STORM WATER MANAGEMENT DESIGN INTENT

FAIRFIELD
RESIDENTIAL

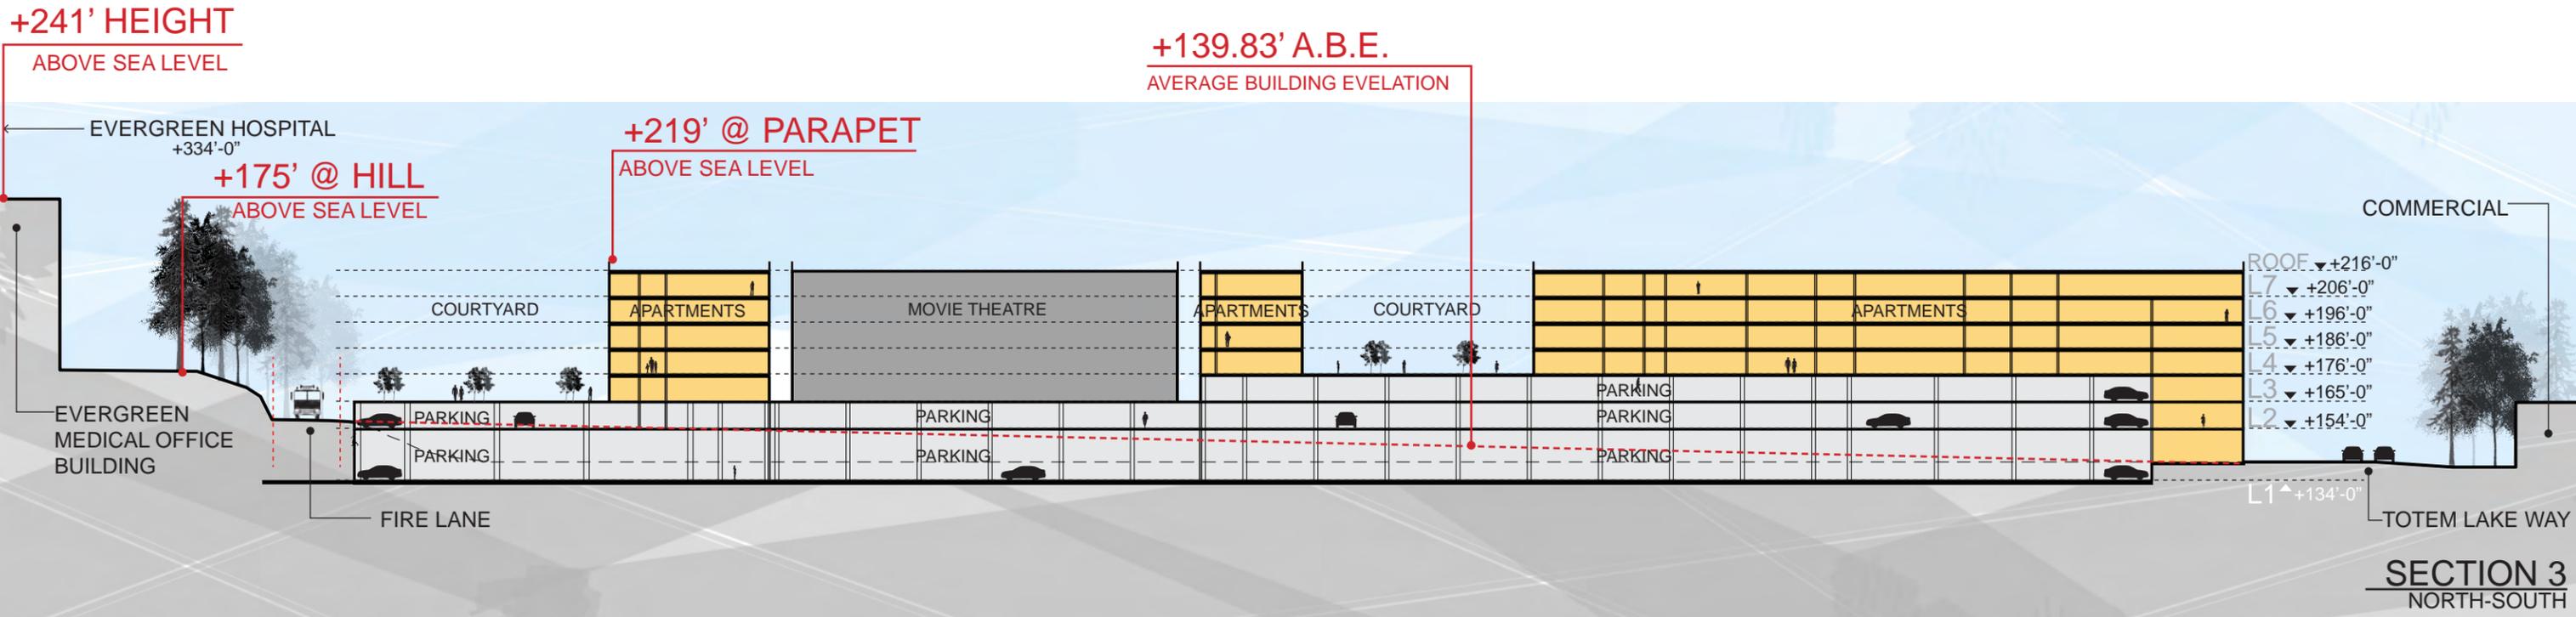
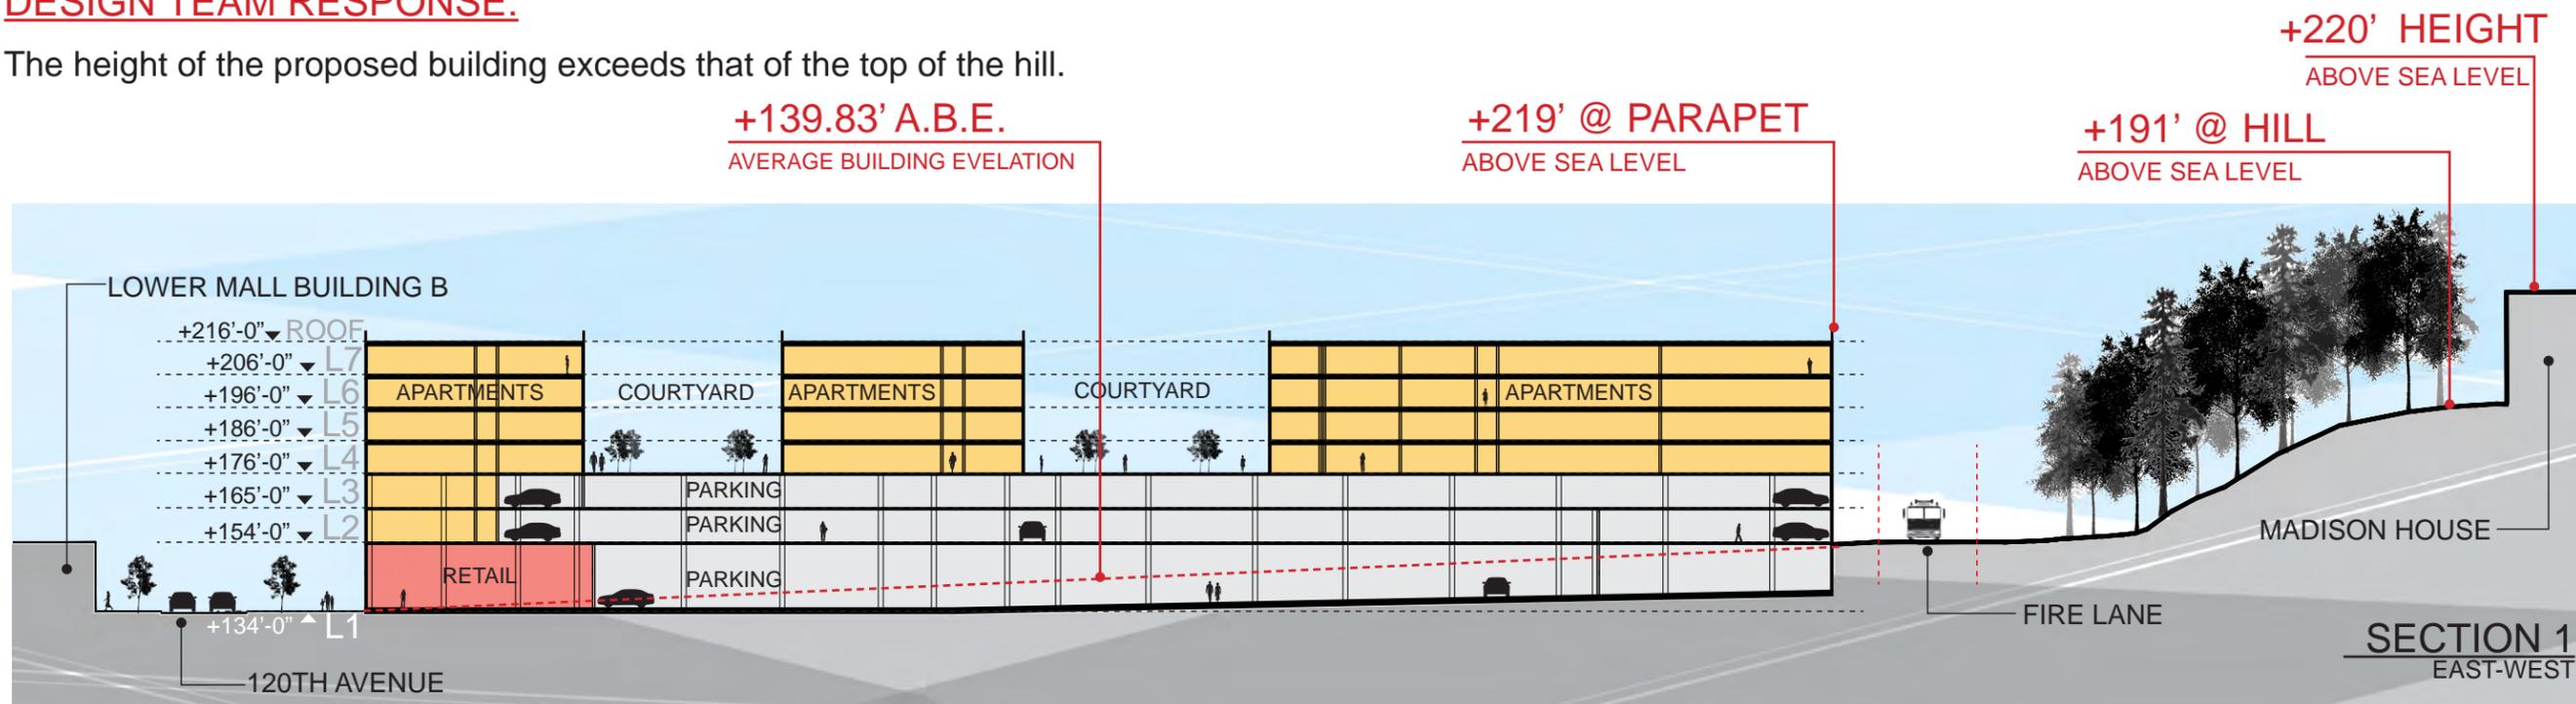
Any intent to break the horizontal datum between retail and residential along 120th? Encourages setbacks and addressing the human scale

Along 120th setbacks have been introduced at key locations above the retail level. To break the datum select massing elements express themselves all the way to the ground level also adding verticality. Distinct materials have been introduced to bring variety to the ground plane.

LEVEL HEIGHT CALCULATION

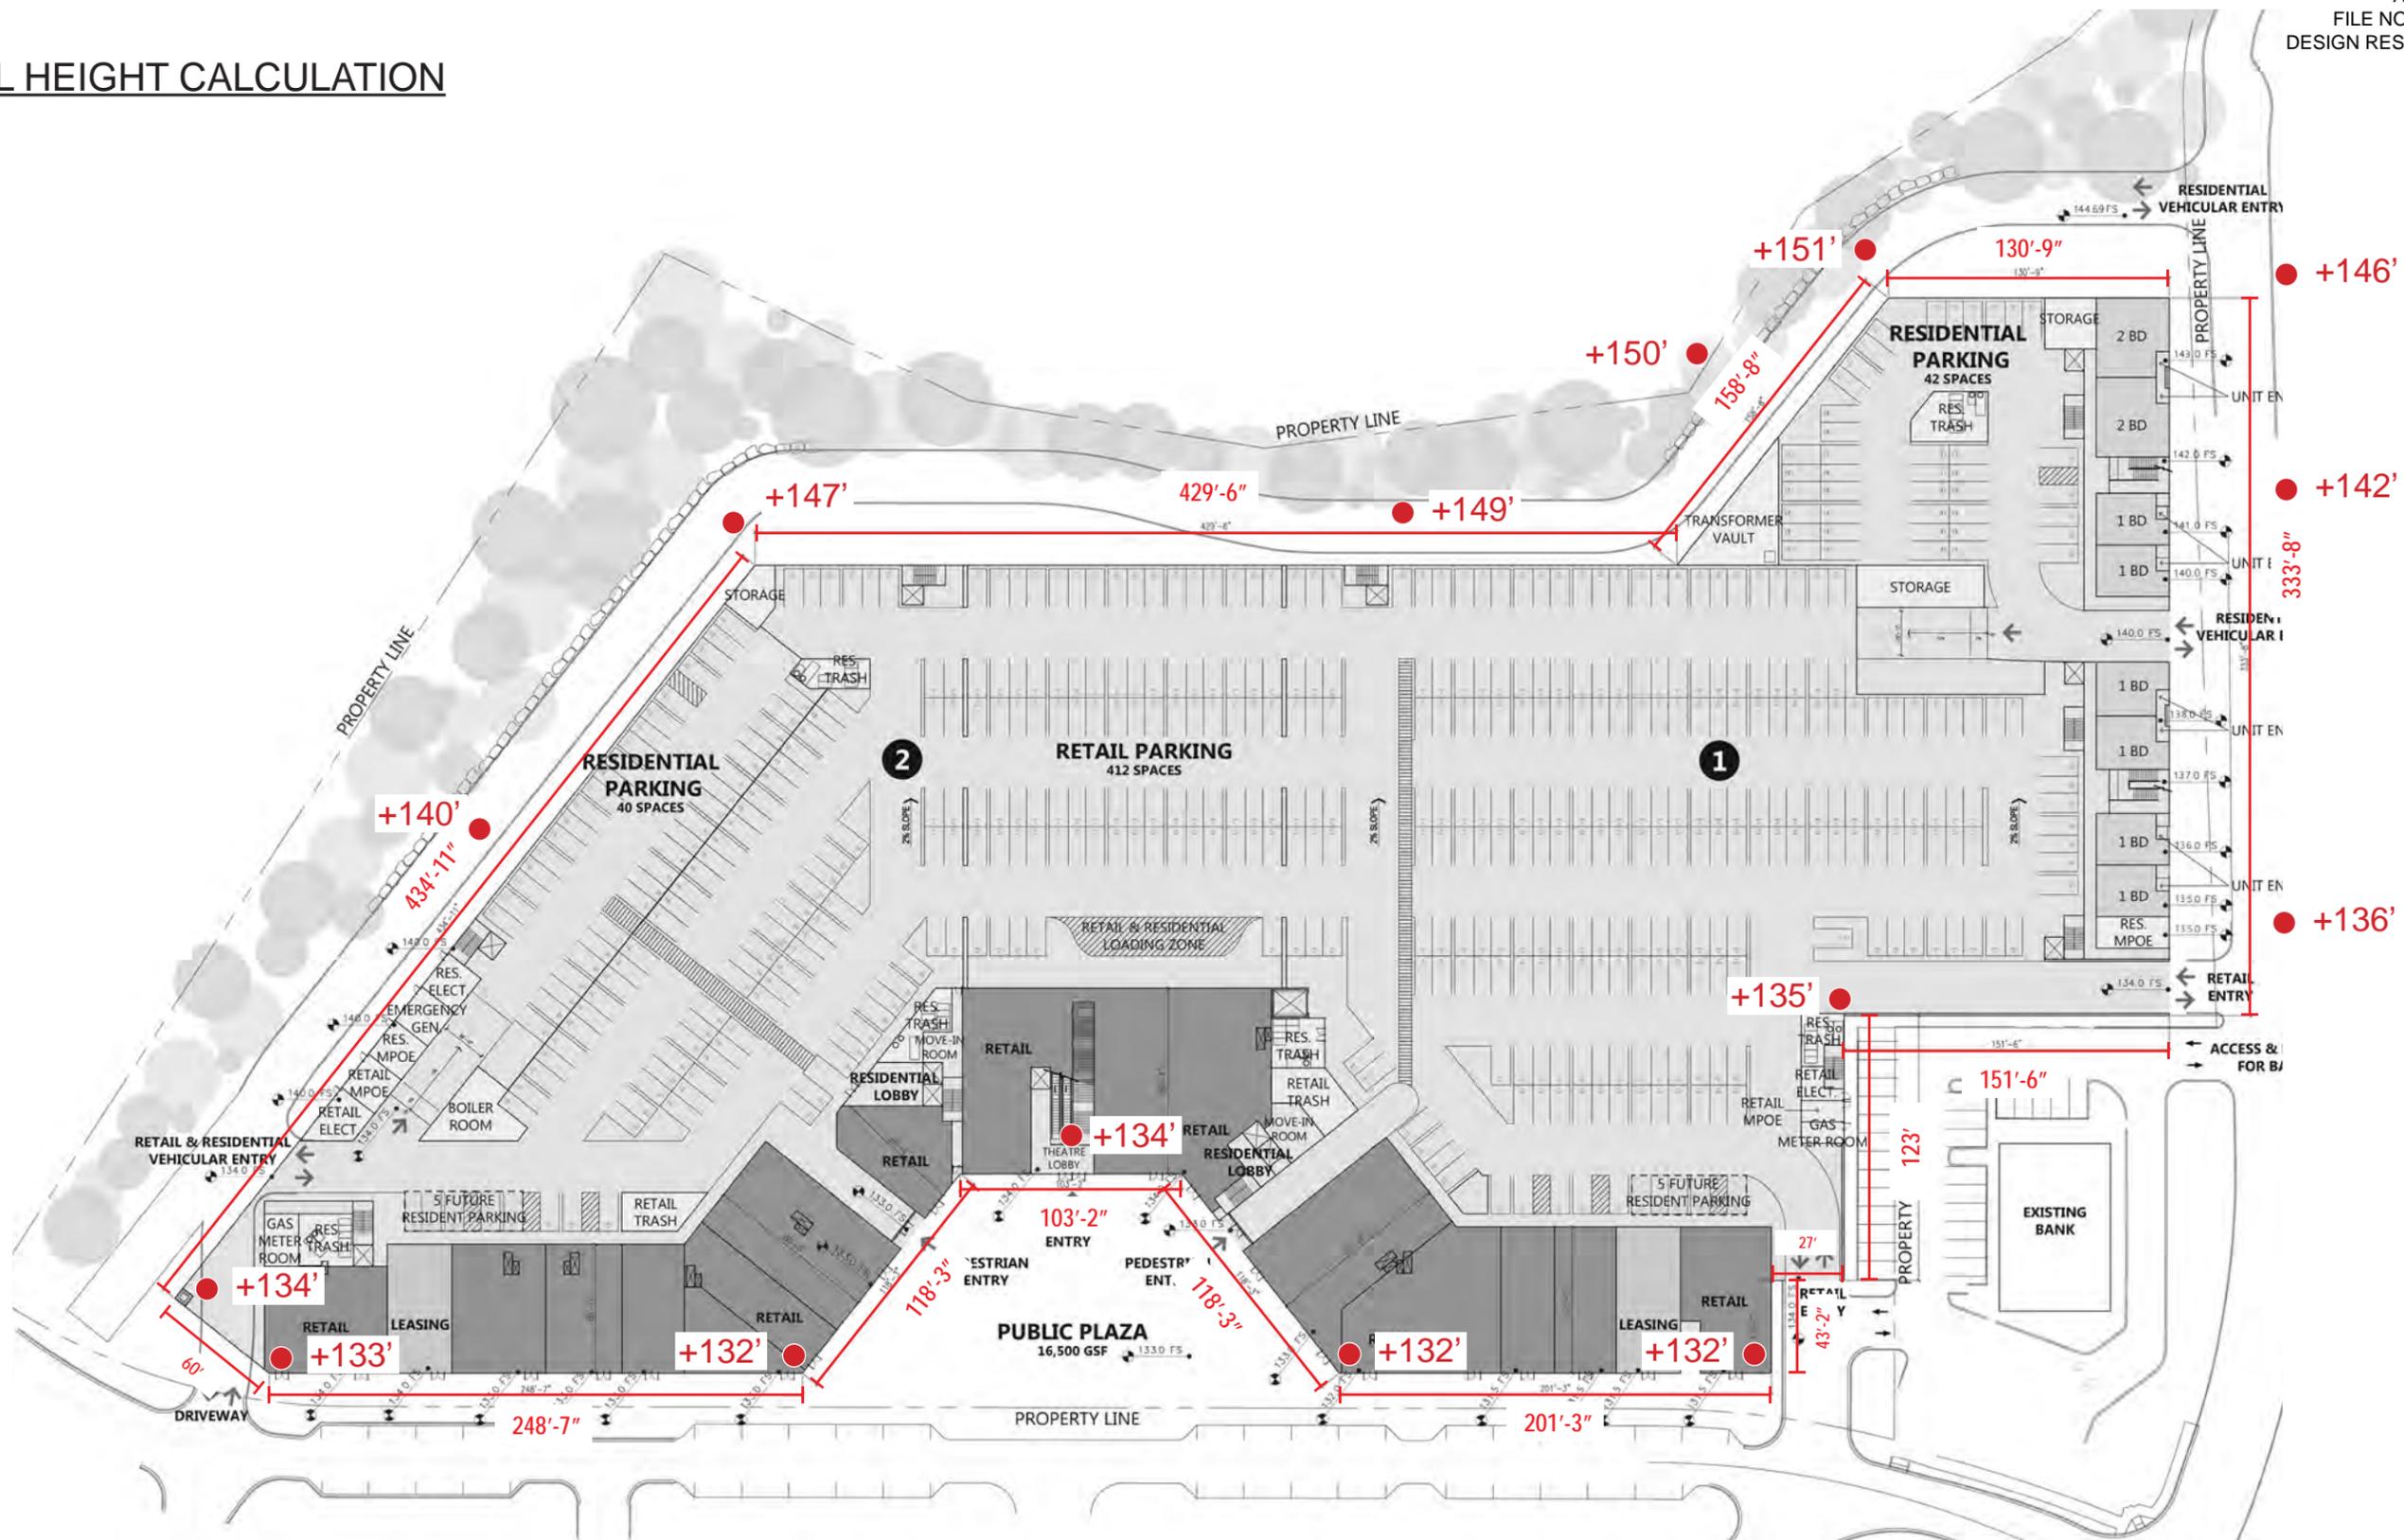
Due to surrounding context a large number of people will be looking down on the project. Has any thought been given to the roof planes?

The height of the proposed building exceeds that of the top of the hill.
